March 25, 2014

**RE: MODIFICATION OF JORGENSEN FORGE EARLY ACTION AREA  
REMOVAL ACTION AND JORGENSEN FORGE OUTFALL SITE REMOVAL  
ACTION BOUNDARIES**

**Figure 1**  
Existing and Revised Jorgensen Forge EAA Removal Action and JFOS Removal Action Boundaries  
Jorgensen Forge Early Action Area

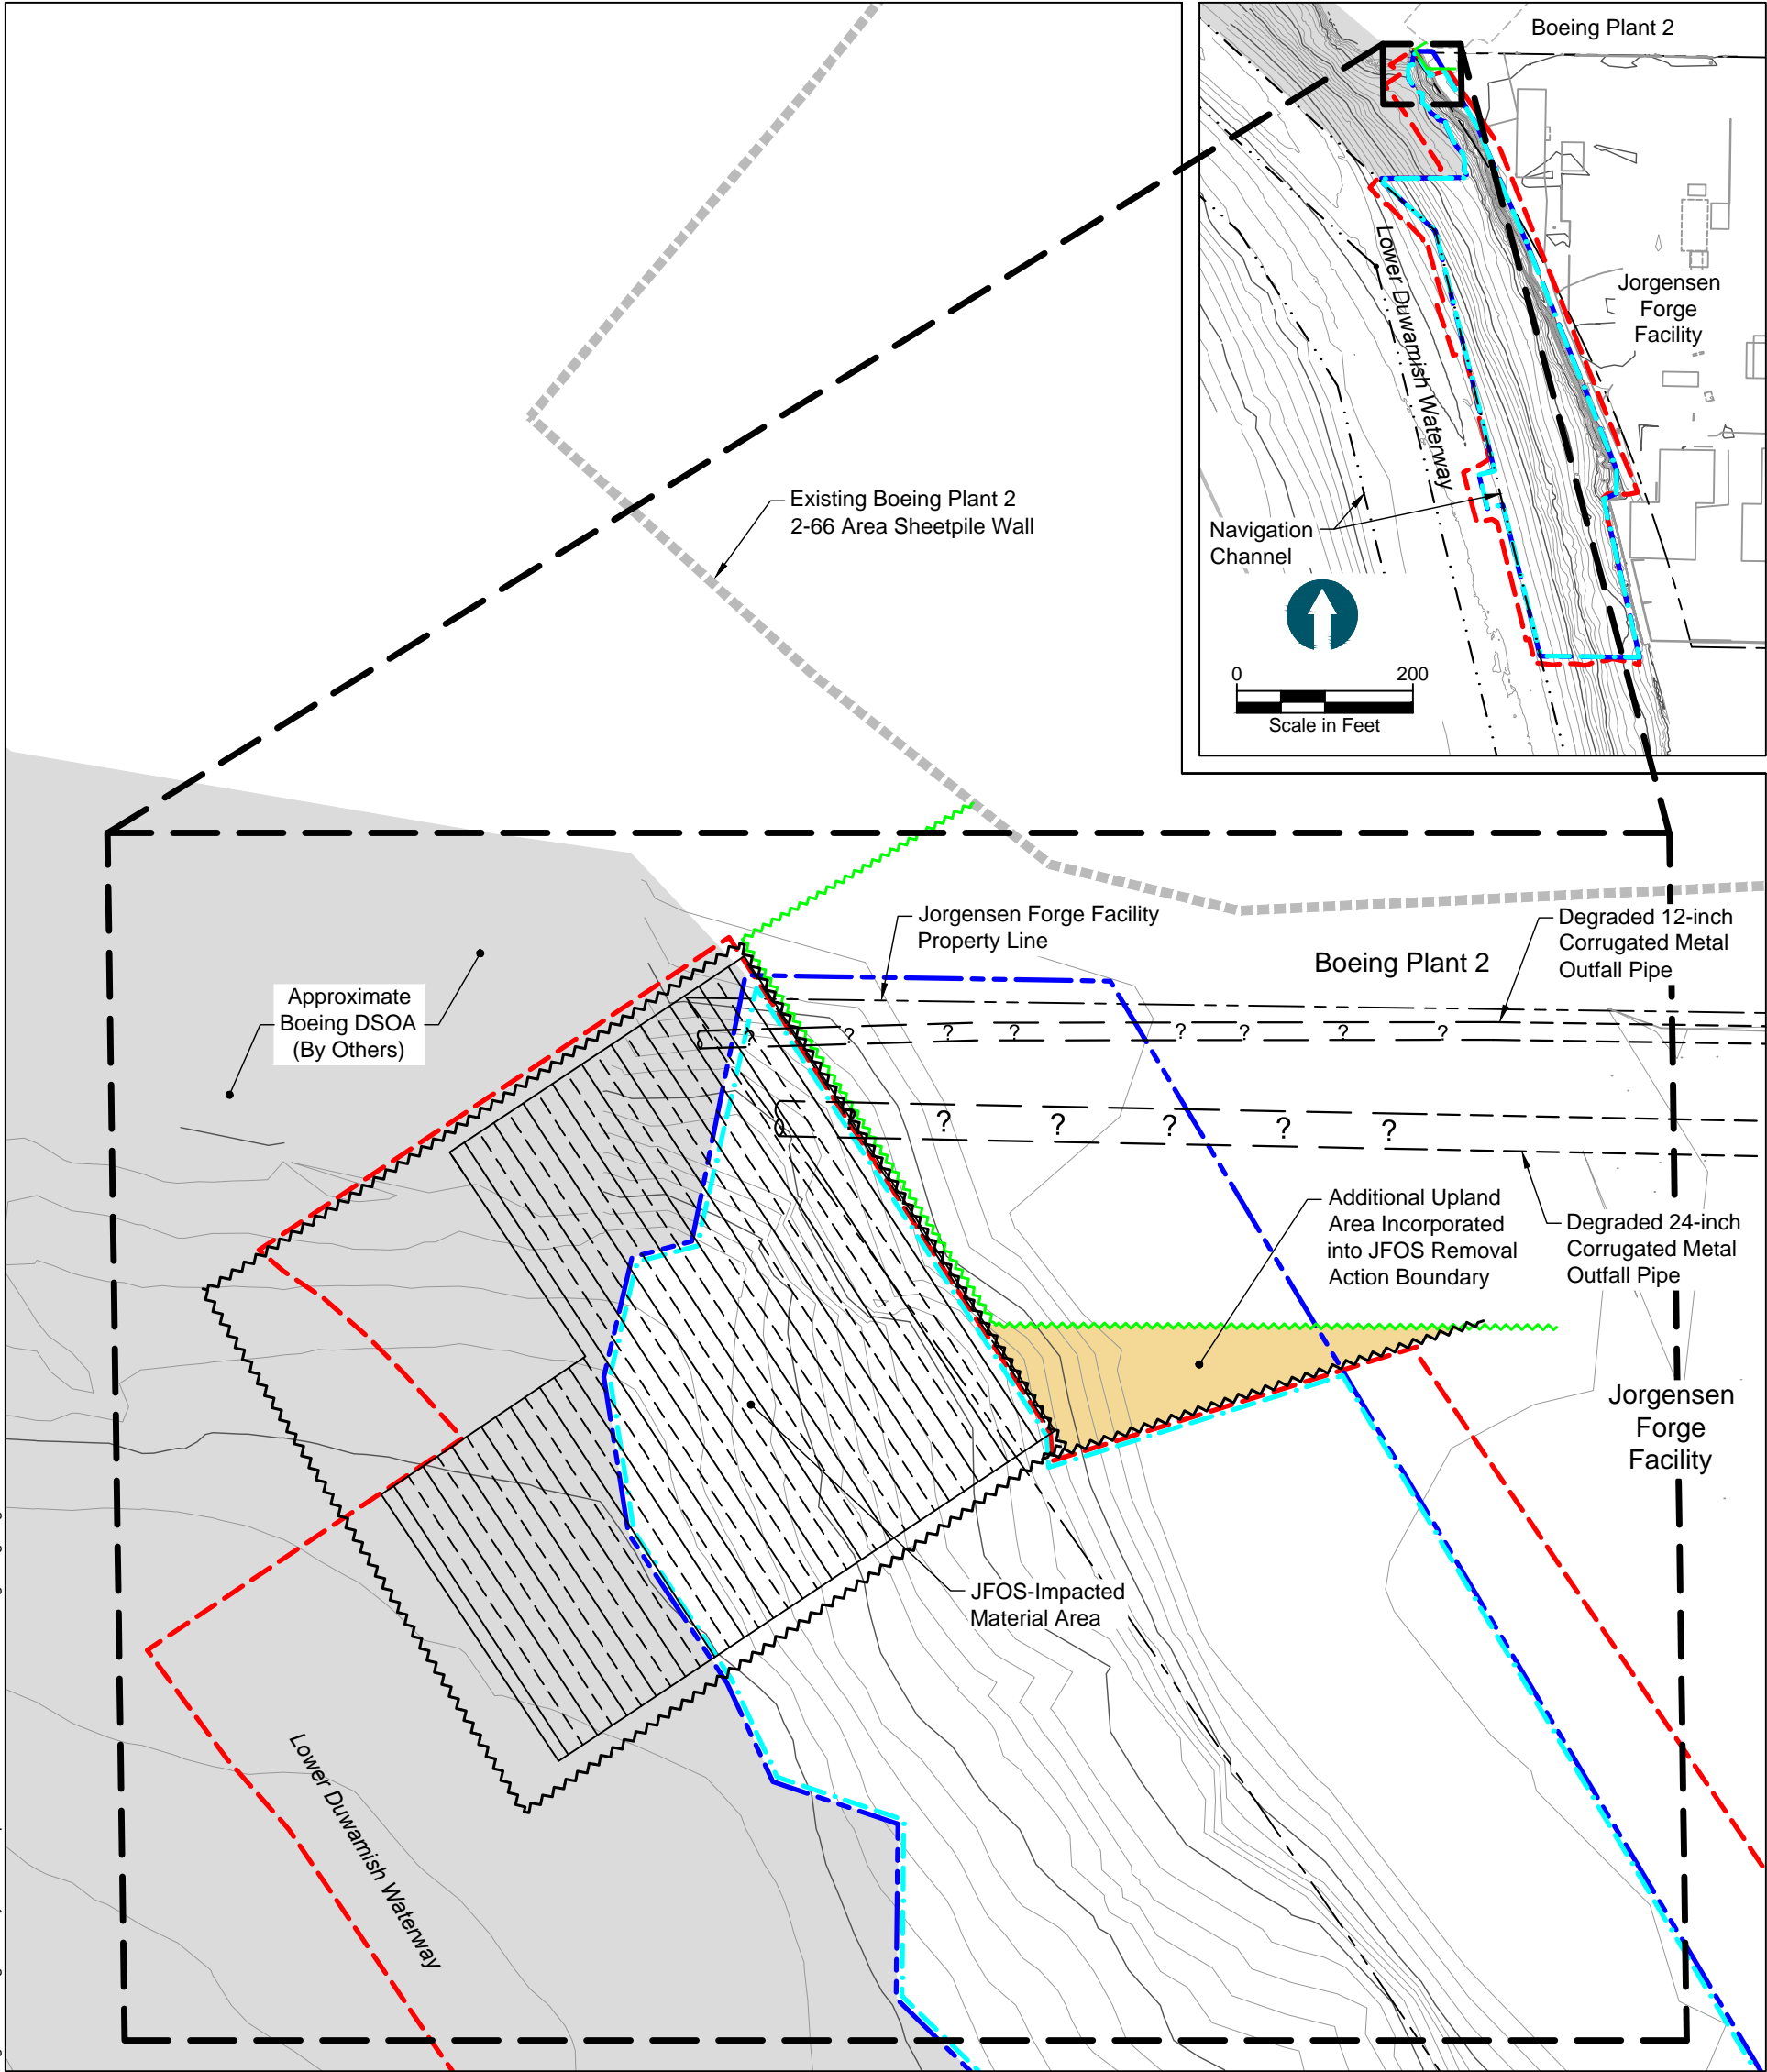
EPA is requiring EMJ to remove the elevated PCB concentrations in the JFOS-Impacted Material Area pursuant to the Jorgensen Forge EAA Removal Action AOC. To that end, EMJ developed a revised, deeper dredge prism in the JFOS-Impacted Material Area. EPA provided written approval on January 23, 2014 for Jorgensen Forge and Boeing to design and construct the coffer dam alignment surrounding the full extents of EMJ's revised dredge prism. As shown on Figure 1, the coffer dam top-of-bank segment extends approximately 8 feet south (upriver) of the southern boundary of the JFOS Removal Action boundary as was depicted in the JFOS Order Second Modification Figure. Figure 1 also shows that this 8-foot upriver extension results in an irregularly shaped corner in the Jorgensen Forge EAA RAB (see tan triangle).

As described in the EPA-approved Jorgensen Forge EAA Removal Action Basis of Design Report dated August 2013, EMJ is required to perform bank excavation and subsequent placement of shoreline containment materials in the irregularly shaped corner. As discussed with EPA during the meeting on January 21, 2014, the Parties have constructability and construction work health and safety concerns associated with attempting to perform the required work in this corner as part of the EMJ removal action. Due to these concerns, the Parties propose to realign the shared JFOS Removal Action boundary and Jorgensen Forge EAA RAB approximately 8 feet upriver to be coincident with the southeastern corner of the coffer dam as shown on Figure 1. This slight modification will result in a 97-square-foot increase in the upland area encompassed by the JFOS Removal Action boundary and an equivalent decrease in the Jorgensen Forge EAA RAB area (Figure 1).

Boeing, EMJ, and Jorgensen Forge hereby request written confirmation from EPA that the proposed boundary modification is acceptable.
